ADVENT HEALTH NARCOOSSEE

SUMMARY

<p>Owner Tim Burrill Adventist Health System/ Sunbelt Inc.</p> <p>Applicant Jennifer Strickler Kimley-Horn & Associates, Inc.</p> <p>Project Planner Jacob Ballard</p> <p>Updated: March 6, 2023</p>	<p>Property Location: The subject property is located east of Narcoossee Road and north of State Road 417 (PID: 31-24-08-0000-00-005) (±67.8 acres, District 1).</p> <p>Applicant's Request: Specific Parcel Master Plan (SPMP) approval for a 250,000 square foot hospital, a 50,000 square foot medical office building, and a parking garage.</p>	<p>Staff's Recommendation: Approval of the request, subject to the conditions in this report.</p>
--	--	--

PROPOSED SITE PLAN

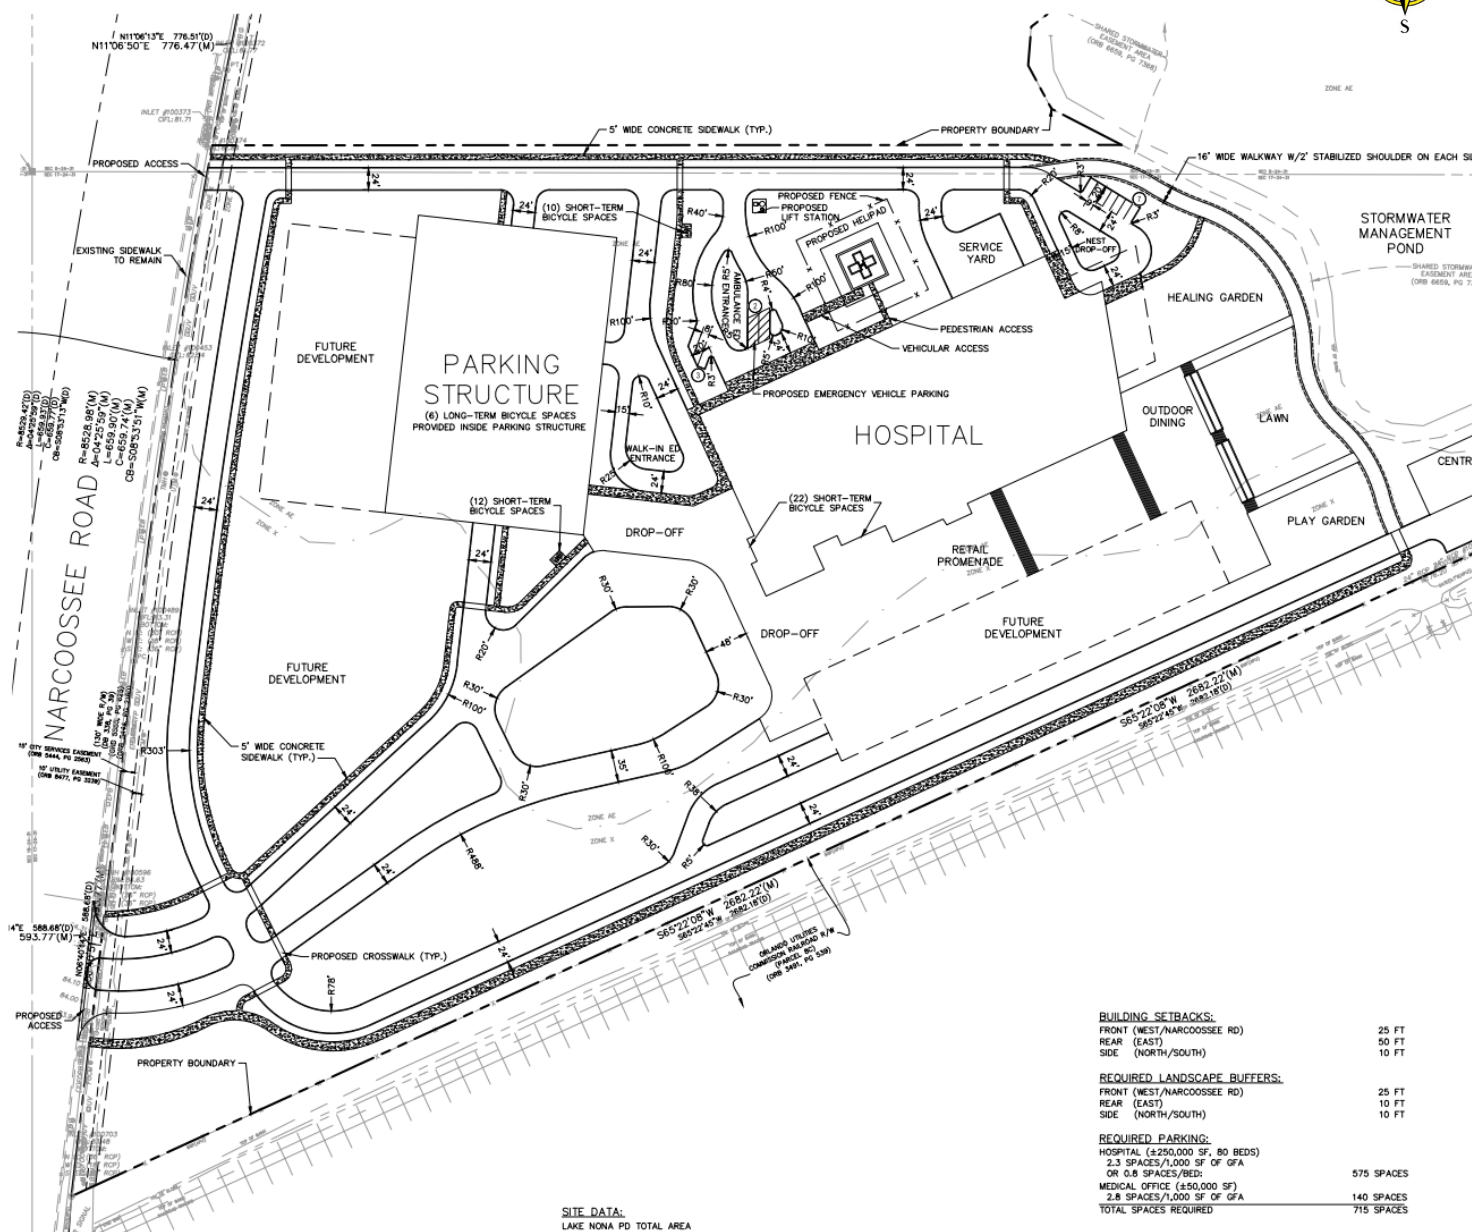
The site plan depicts a helipad on the central portion of the property. According to Chapter 8, Section 8.21 of the City Code provides classification of heliports. A "Type B heliport" is a heliport operated by a hospital or air ambulance service under a permit issued by the City and used primarily by helicopters operated by such hospital or air ambulance service for the transportation of sick or injured persons, medical personnel, and medical supplies; Type B heliports may not be used for the loading or unloading of passengers, baggage or freight carried for hire and no charge may be made or paid for the use thereof,

For "Type B" Heliports, upon the application of a hospital or air ambulance service for a permit to establish and operate a Type B heliport primarily for use by its rescue helicopters in the conduct of the hospital or air ambulance business conducted by it, the City may grant a Type B heliport permit, as a Building Permit through the Office of Permitting Services, to such hospital or air ambulance service permitting the establishment and operation by such applicant for a Type B heliport at the location described in the application. Nothing contained in LDC Chapter 58, Part 4P shall be deemed to prevent the establishment or operation of a Type B heliport if a permit therefore is issued pursuant to this section. The Applicant has not yet provided information regarding the frequency of flights at this helipad.

Additional information on helipad type and the frequency of flights per week based on expected operations at this facility prior to applying for building permits.
